# FINDING OF NO SIGNIFICANT IMPACT

## ILLINOIS STREET RECONSTRUCTION PROJECT

PROJECT NO. STP-F-M-0663(4)

Re: Illinois Street Reconstruction  
Project STP-F-M-0663(4)/63102  
**Finding of No Significant Impact**

STATE	ALASKA
PROJECT DESIGNATION	PROJECT DESIGNATION
YEAR	2005
SHEET NO.	F15

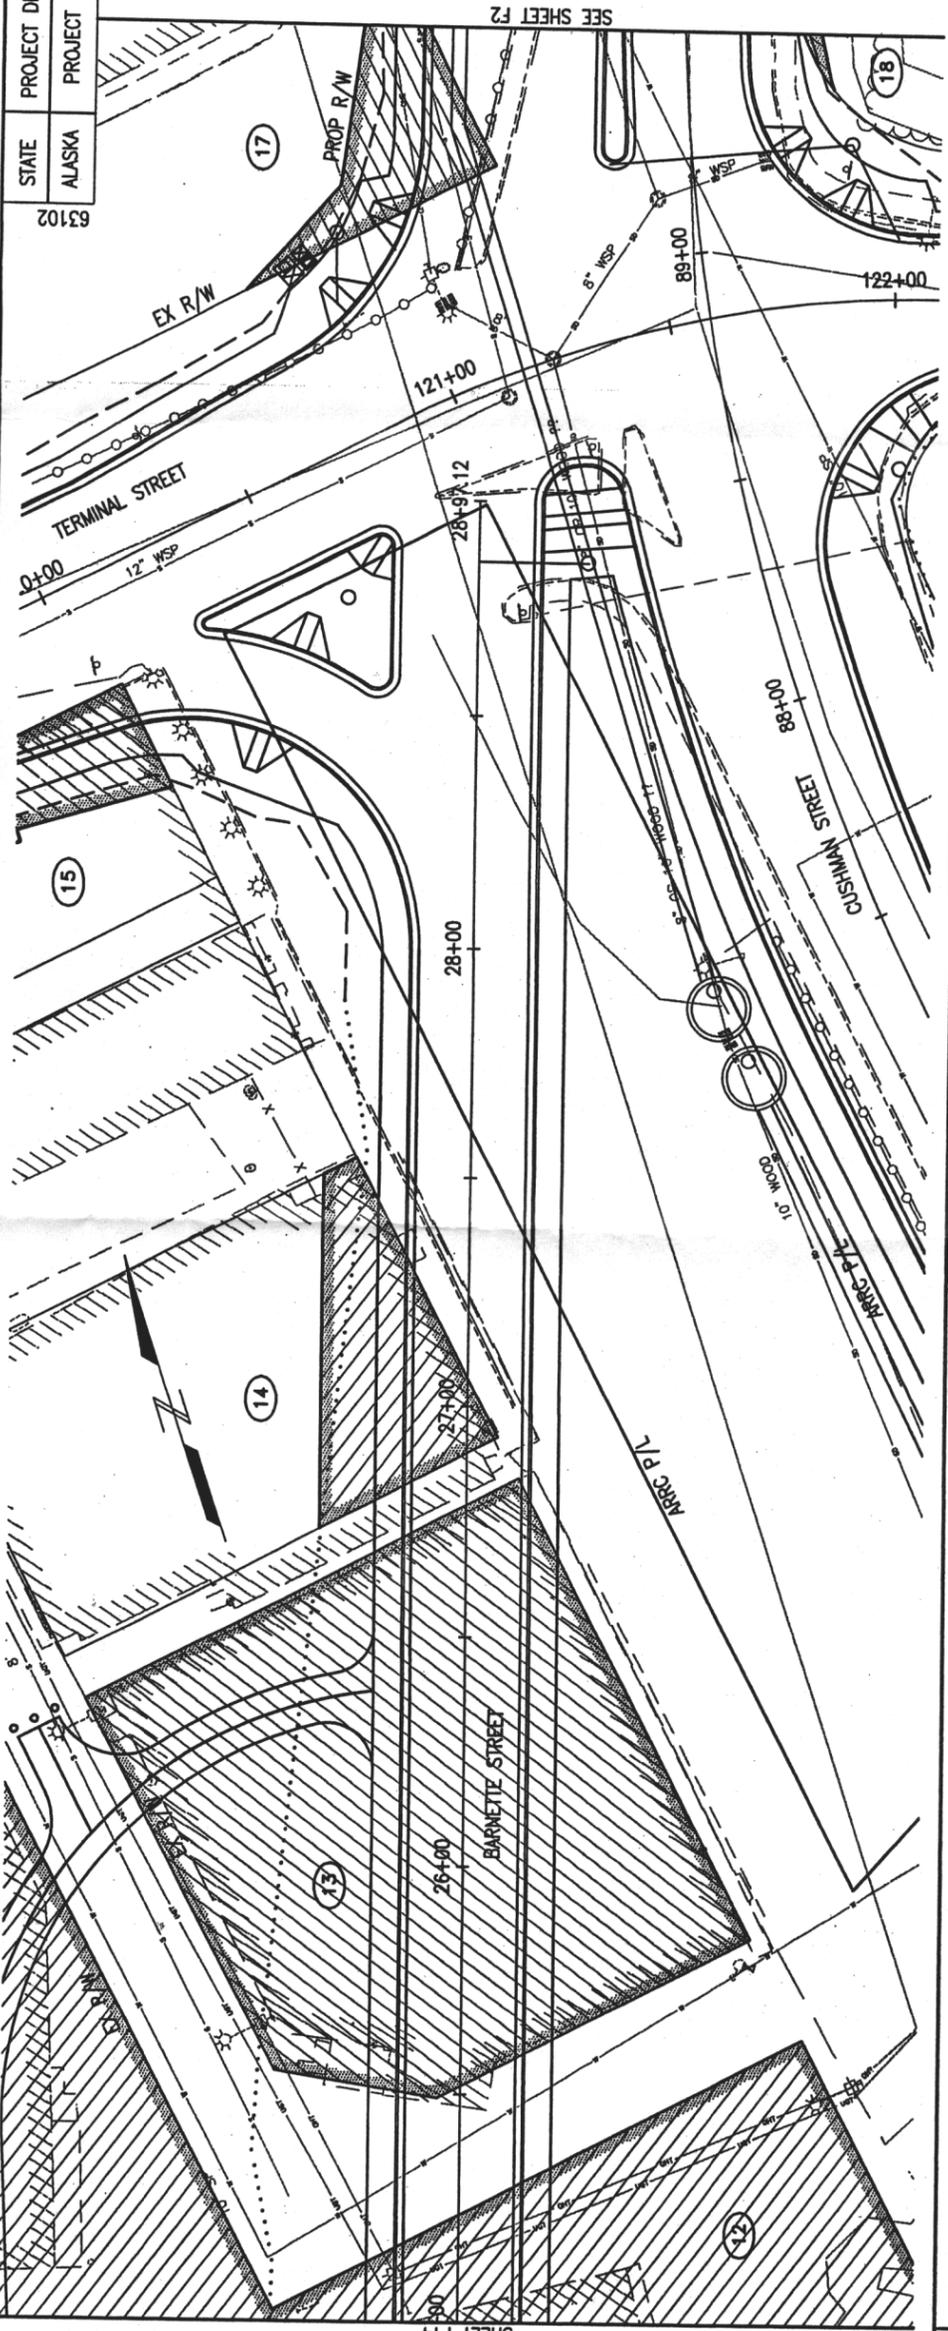
The Chena Riverfront Path will extend under both the new Cushman and Barnette Street Bridges and connect to Barnette Street near the existing Samson's Hardware location. This path design will require the full acquisition of the Jackovich Apartment property and the removal of the existing warehouse behind Samson's Hardware (See Errata Figures F15 and F23).

**INSERT NEW PARAGRAPH:** The Chena Riverfront Path will extend under both the new Cushman and Barnette Street Bridges and connect to Barnette Street near the existing Samson's Hardware location. This path design will require the full acquisition of the Jackovich Apartment property and the removal of the existing warehouse behind Samson's Hardware (See Errata Figures F15 and F23).

REVISIONS	NUMBER	DATE	DESCRIPTION
1	3-18-05	ADDED DRIVES & STORM DRAIN	
SHEET NO. SF YEAR 2005 PROJECT DESIGNATION F16 T STATE ALASKA PROJECT DESIGNATION F16 T 63102

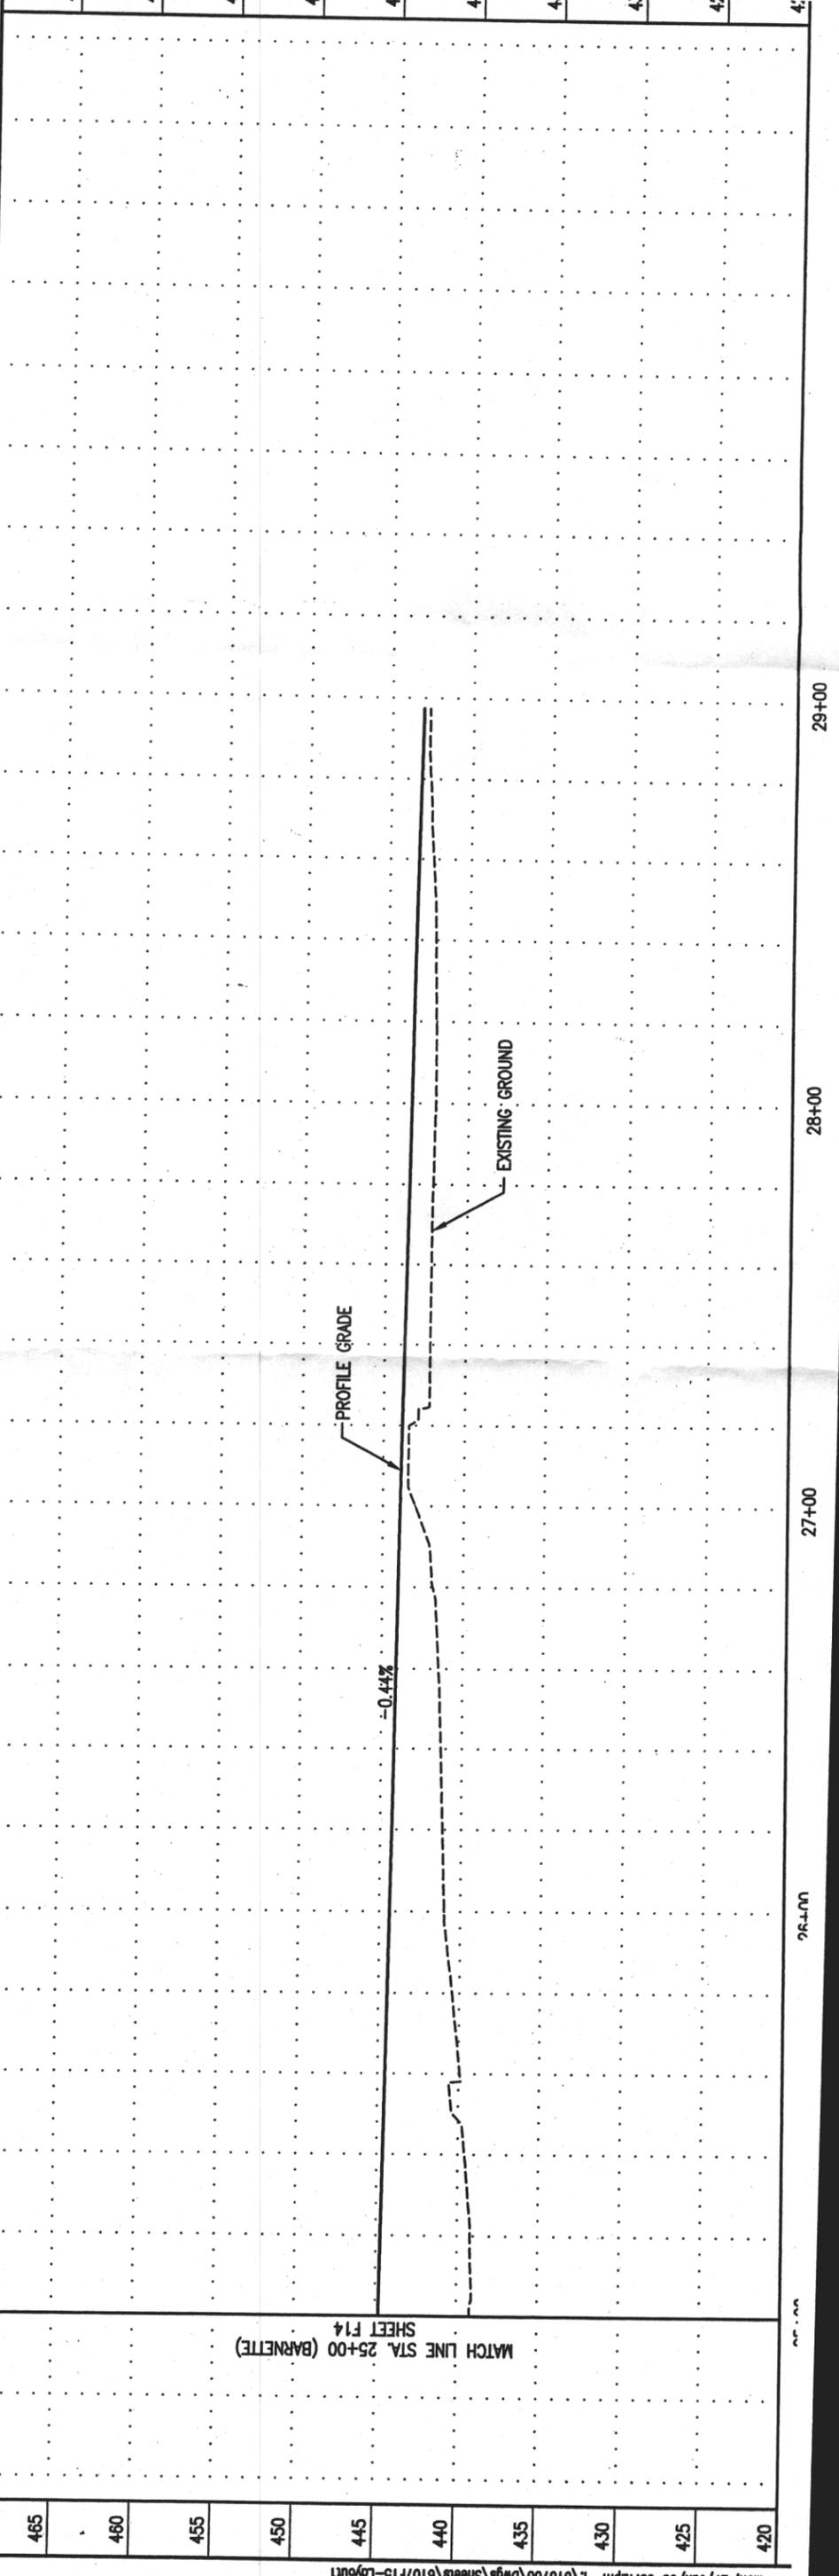
**INSERT:** Improvements to 1<sup>st</sup> Avenue west of Barnette Street would extend about 120 feet west of the 1<sup>st</sup> Avenue/Barnette Street intersection, which is a reduction of about 80 feet from previous design (See Errata Figure F16).
